SUBJECT: Site Plan Approval – 111 Breen Avenue and 710 Arsenal Street

Request: Site Plan Approval for to construct a 10-space parking lot expansion and associated site improvements at **111 Breen Avenue**, Parcel Number 8-01-214.100 and **710 Arsenal Street**, Parcel Number 8-01-219.001

2017-015.04 SITE DEVELOPMENT DRAWINGS - 05/15/2026
PETE'S TRATTORIA PARKING LOT EXPANSION PROJECT

8 | DRY WELL DETAIL
C501 | NOT TO SCALE

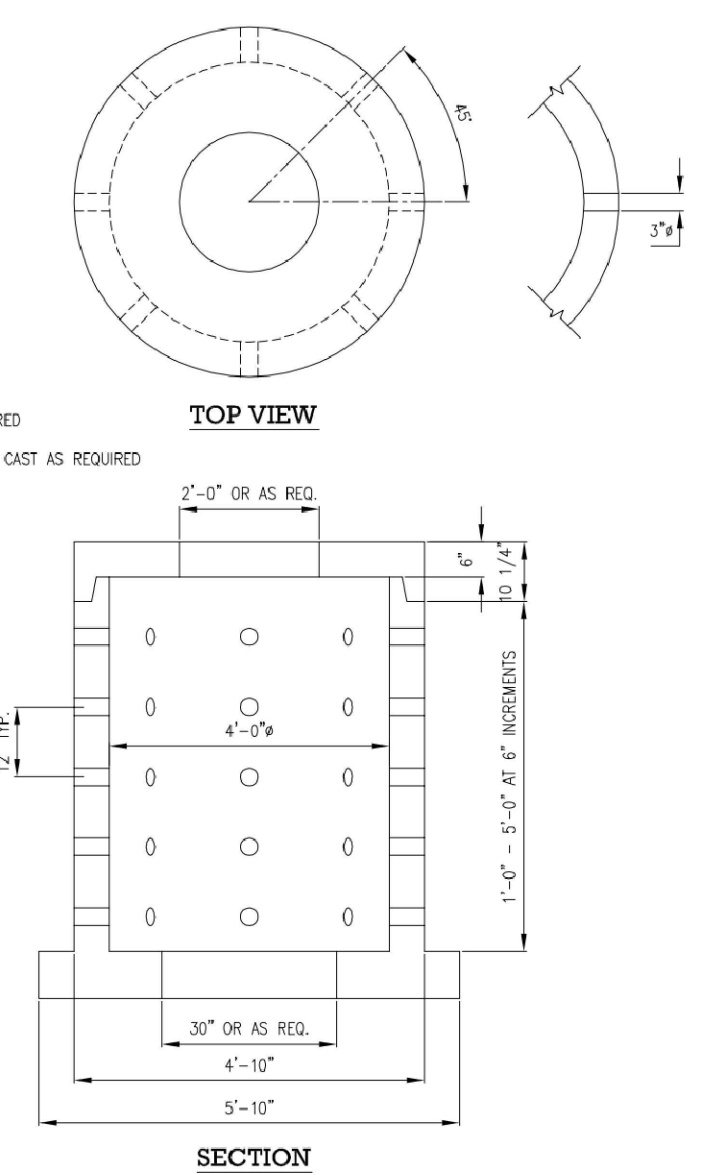
The applicant shall add the identified dry well drainage infrastructure to the C102 drawing. Additionally, the applicant shall submit pre-and-post-construction stormwater drainage calculations to prove that the existing and proposed drainage infrastructure can accommodate the increase water volume.

UTILITY AND GRADING PLAN
PETE'S TRATTORIA PARKING LOT EXPANSION

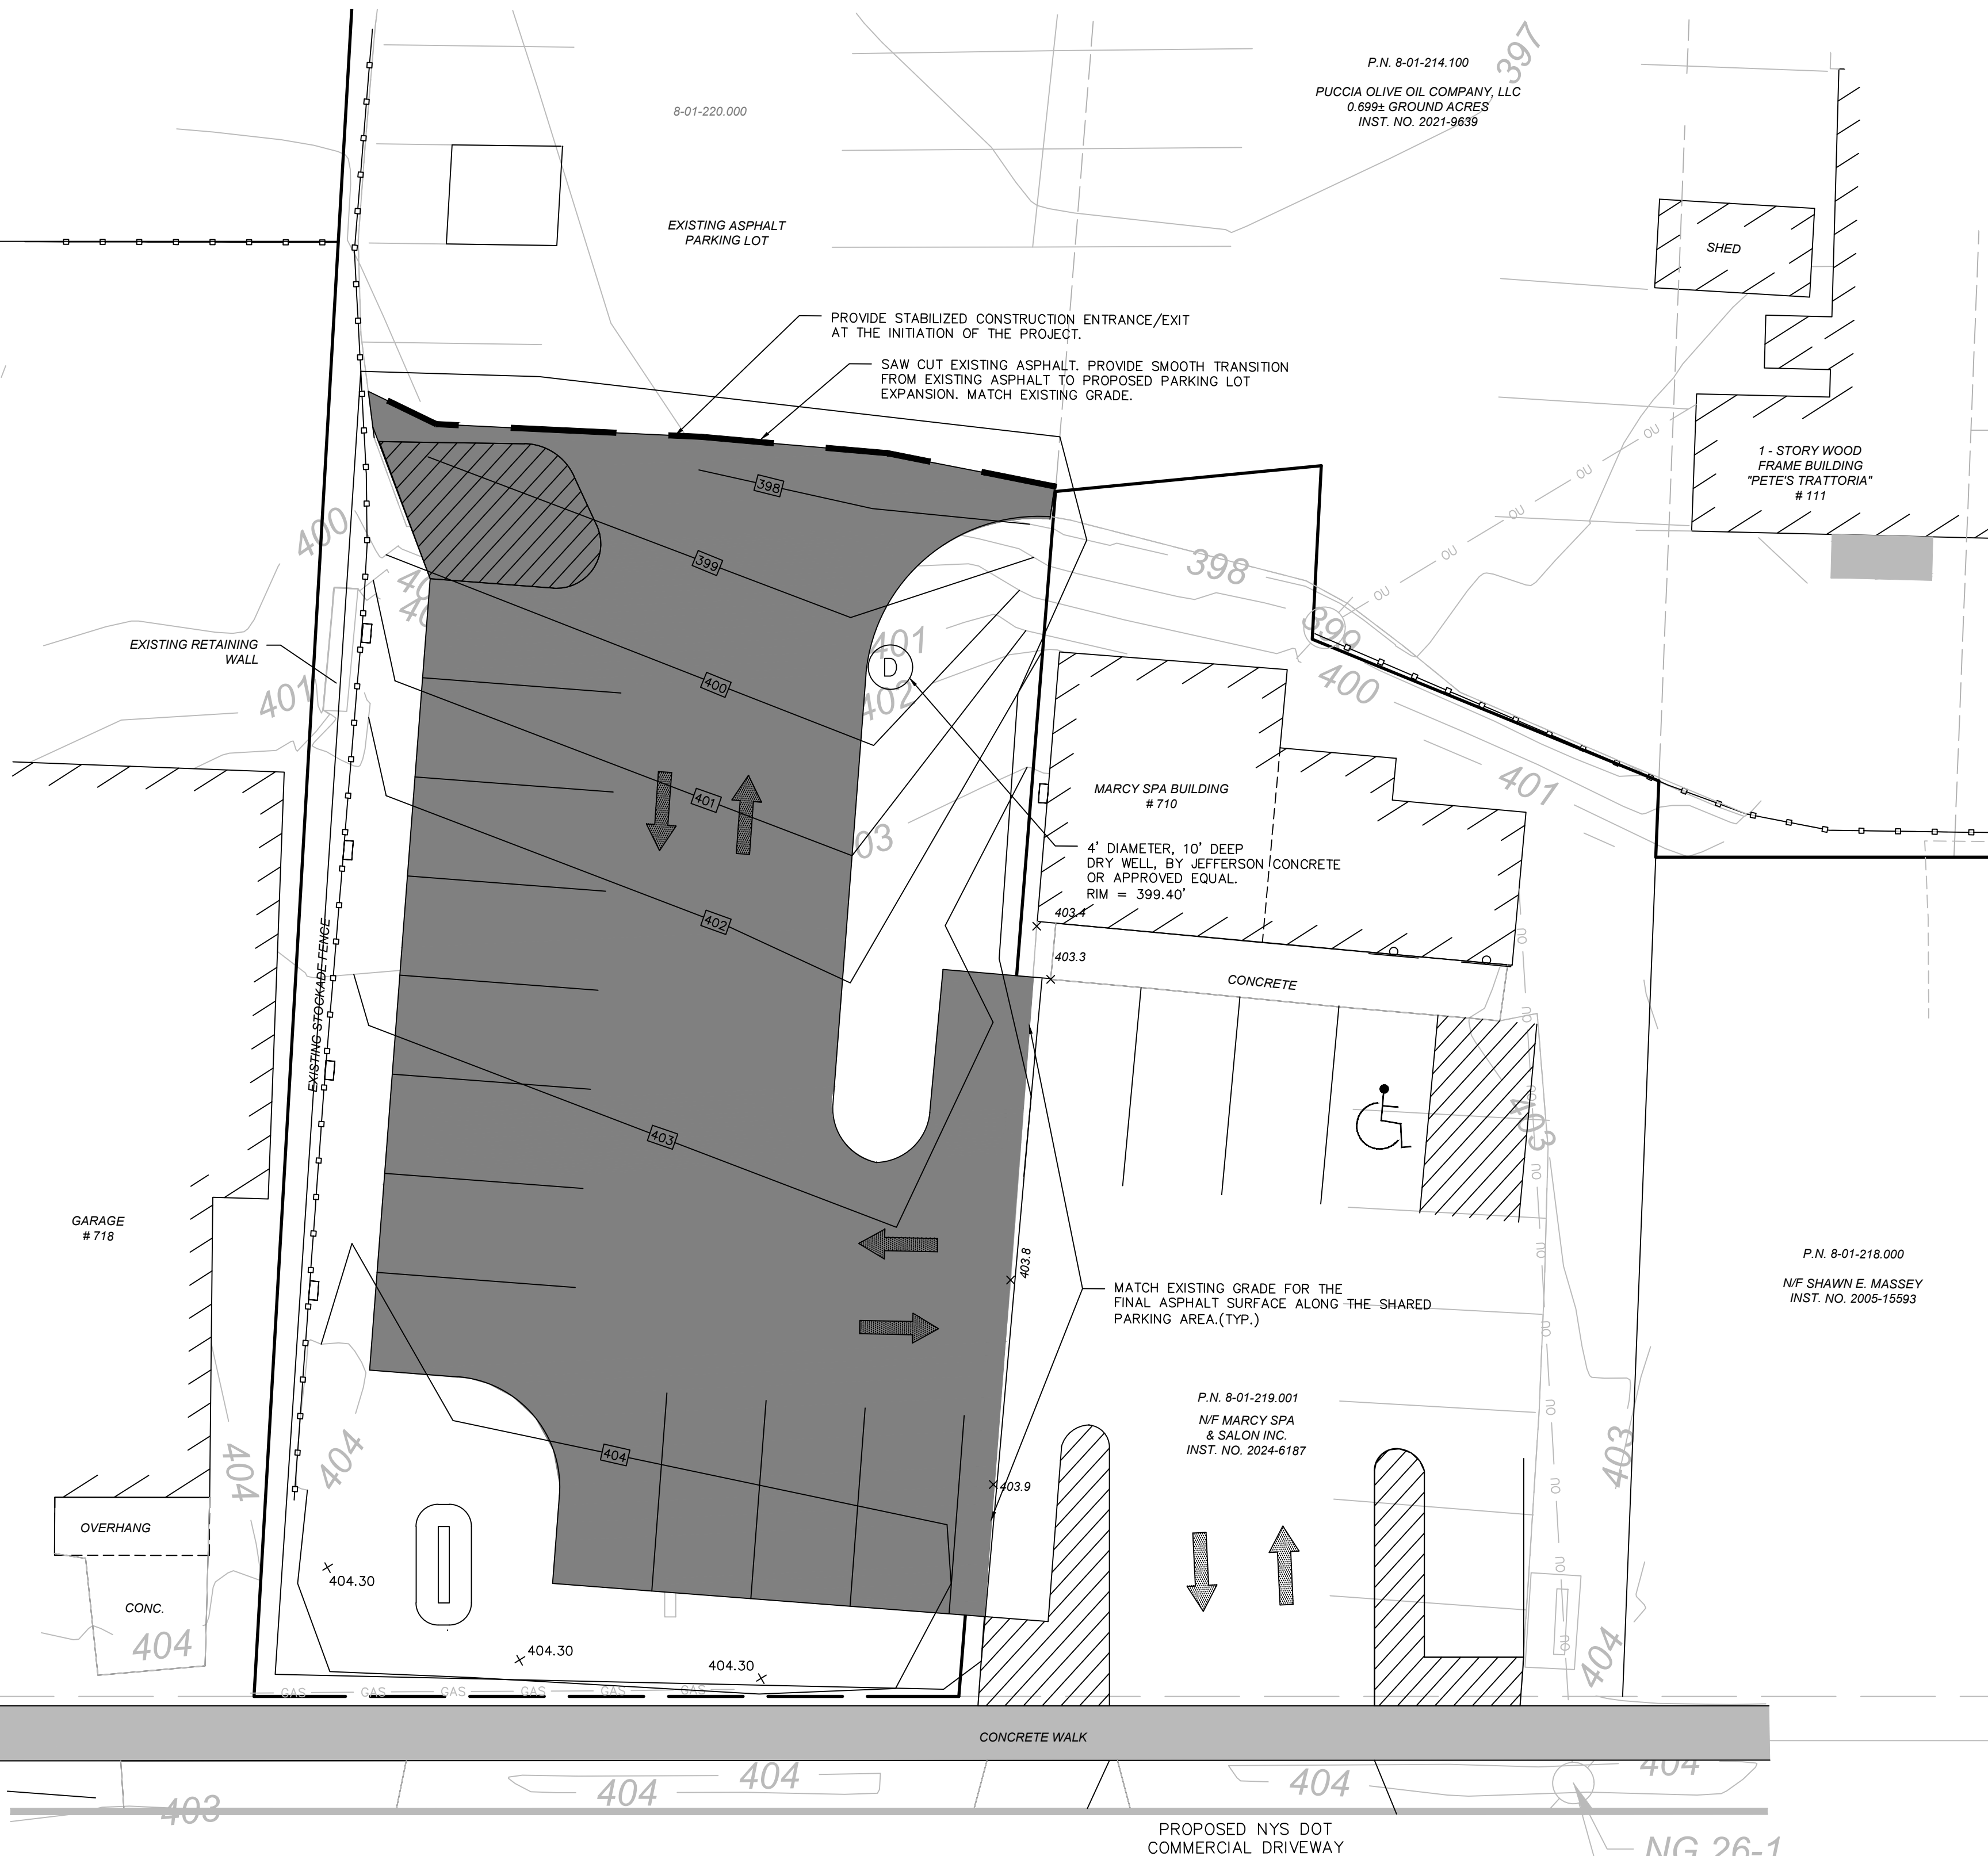
Grading, Drainage and Utilities: The applicant states in the cover letter/application narrative that stormwater planning has occurred with the proposed grading directing the majority of the onsite storm water runoff to a proposed dry well system and that stormwater from the proposed access road to the new parking is anticipated to be captured and infiltrated by an existing dry well system in the existing, northerly parking lot.
